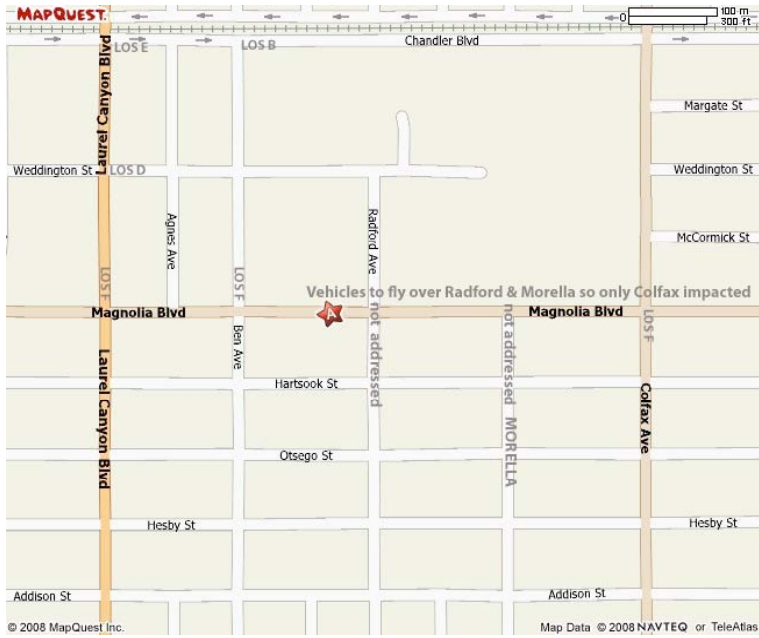
4. The standard used to calculate peak hour trips generated in the report is a national standard from 2003 and bears no relation to Los Angeles traffic. Wendy Greuel admitted to residents at our meeting that she asked for this to be changed and it is not addressed in the traffic report. Simply stated they do not accurately measure peak trips

generated, project volume to capacity ratios, or the impact to intersections from the projects.

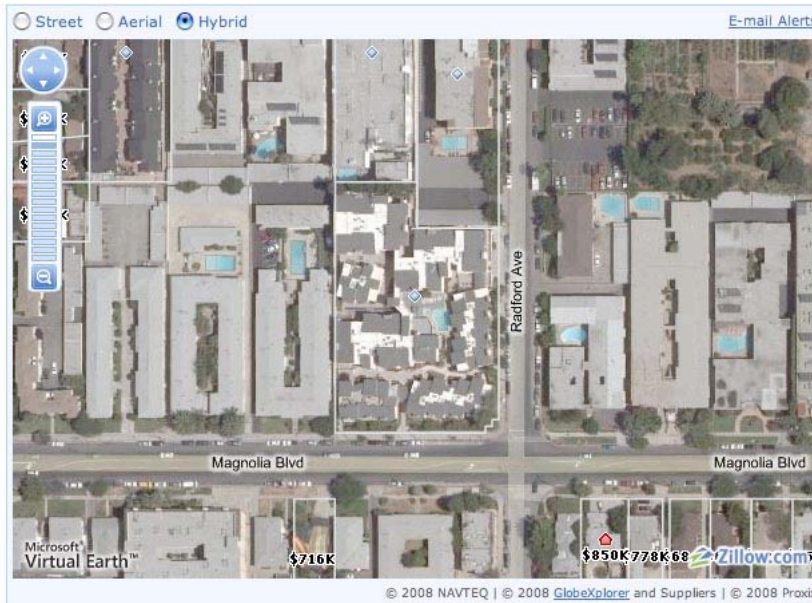
YALE PARTNER’S LETTER to Expedited Subdivision Unit, Room 721, Maya Zaitzevsky and signed by Dan Zacharias dated 10-16-2008 described his project as INFILL which was INCORRECT and fraudulent. We are an RD1.5 property. He described us as R-3/R-4.

NOHO COMMUNITY PLAN COMMENTS: When a preponderance of the parcels within a small area are developed at a density higher than that depicted on the Plan, “infill” at a comparable density may be appropriate on the remaining parcels within the area. The majority of the properties in the surrounding subareas are either RD1.5 or Low /Medium Residential, there is NOT a preponderance of Medium/High Residential.
